**Standard Permit for Solid Waste Landfill
Granite State Landfill – Phase I
Response to NHDES Incomplete Application (#2021-52265)
Douglas Drive
Dalton, NH 03598**

**RE: Granite State Landfill, LLC
Proposed Lined Landfill – Dalton, New Hampshire
Standard Permit Modification – Application # 2021-52265
Response to NHDES Incomplete Application Correspondence**

Bedrock Surface Elevation Contour Plan

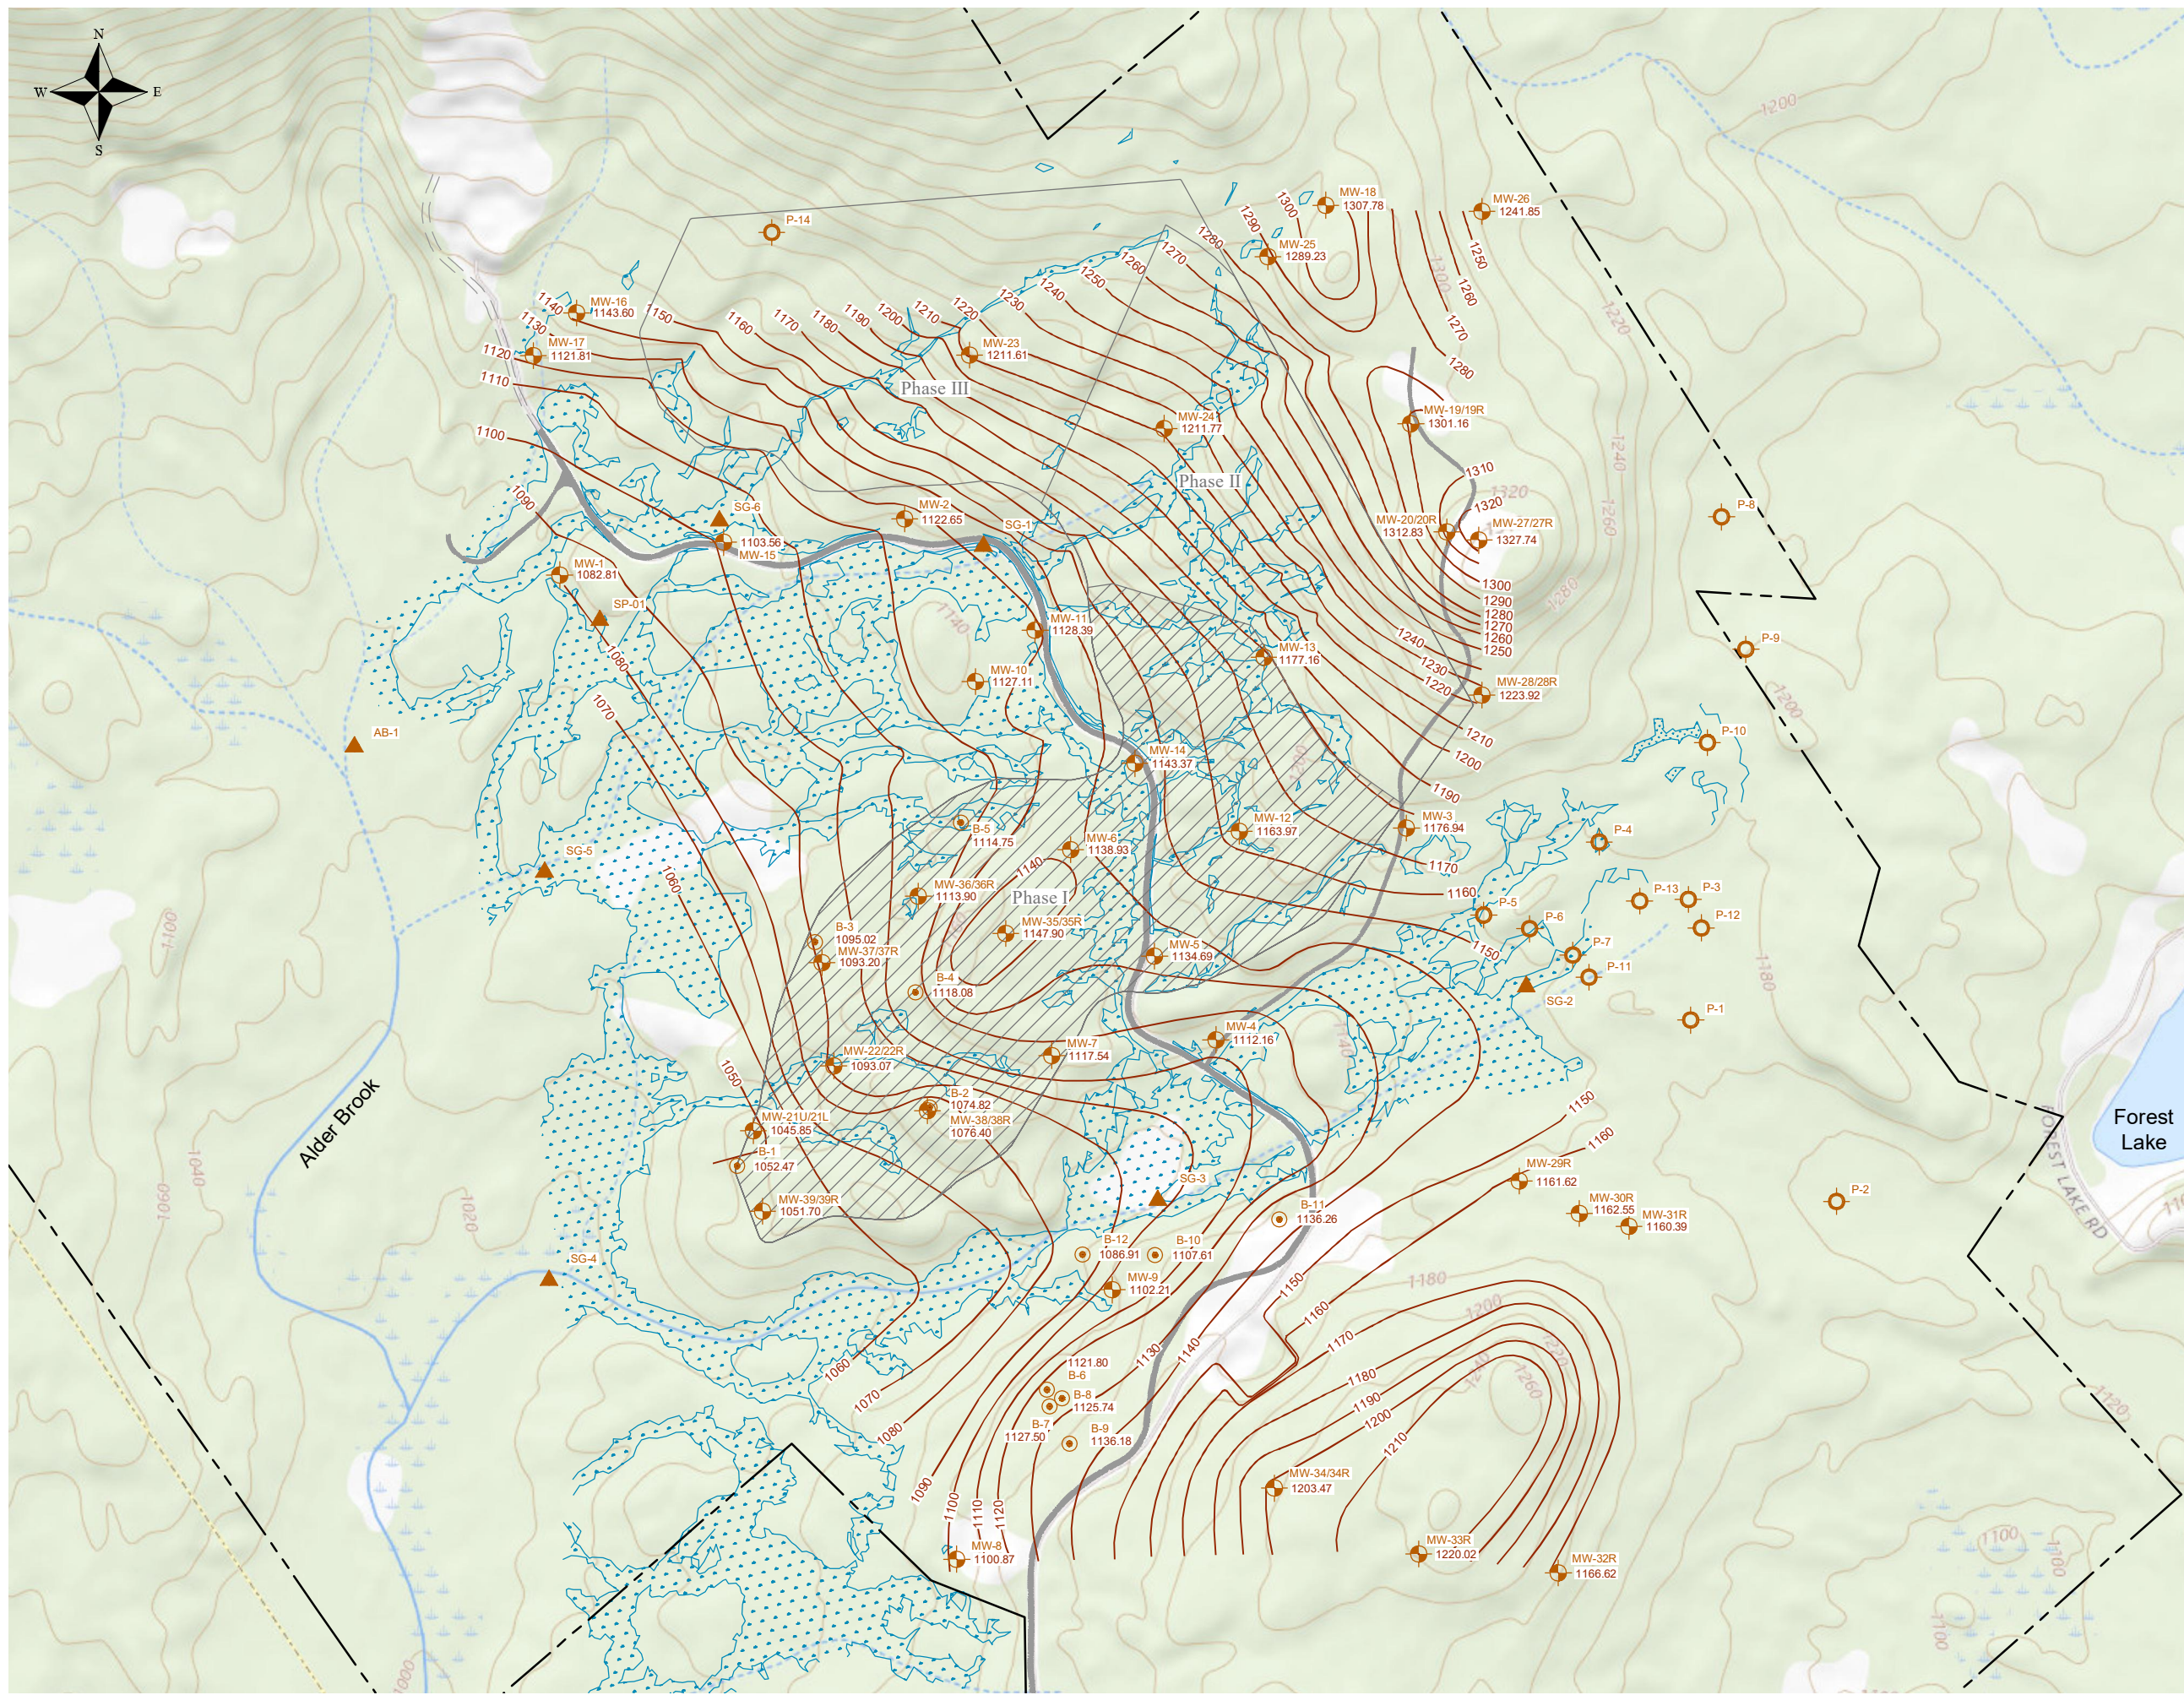
- *The logs of additional borings, laid out in a systematic investigative pattern within the footprint, used to determine depth to bedrock.*

Using the surveyed elevation of the monitoring wells and the observed depth to top of bedrock, an updated bedrock surface plan was prepared (Figure 2). In addition, the locations of the geotechnical borings (B-1 through B-5) installed in 2020 were surveyed

As indicated on Figure 2, the bedrock surface was refined in the vicinity of the new borings.
